PCB-638

DATE OF BULLETIN:
5-31-2017

MODELS AFFECTED:
RECON
MICROMINI

SCOPE OF BULLETIN:
New Stainless Steel Baffle standard
New drop-in Float-ball screen and enlarged Float-ball
New white Vacuum Filter
Retractable front fill-hose

New Drop-In Float Ball

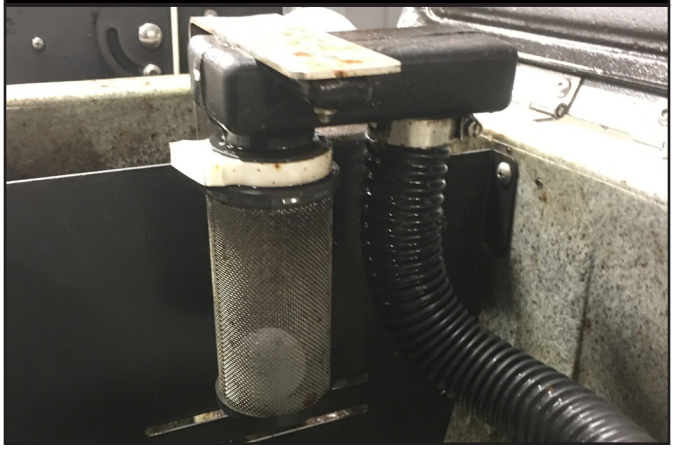
2. New Drop-In Float-Ball Screen to prevent assembly from dropping into tank assembly and enlarged Float-Ball to prevent the potential soap foam from getting into the Vacuum Motor. Enlarged 2" vacuum intake hose for better airflow.

Clean New Filter

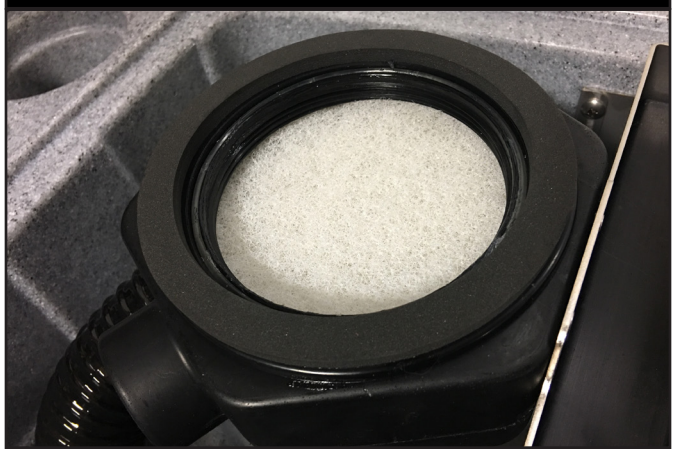
3. New white Vacuum Filter as an added layer to prevent potential soap foam or small particulates into the Vacuum Motor.
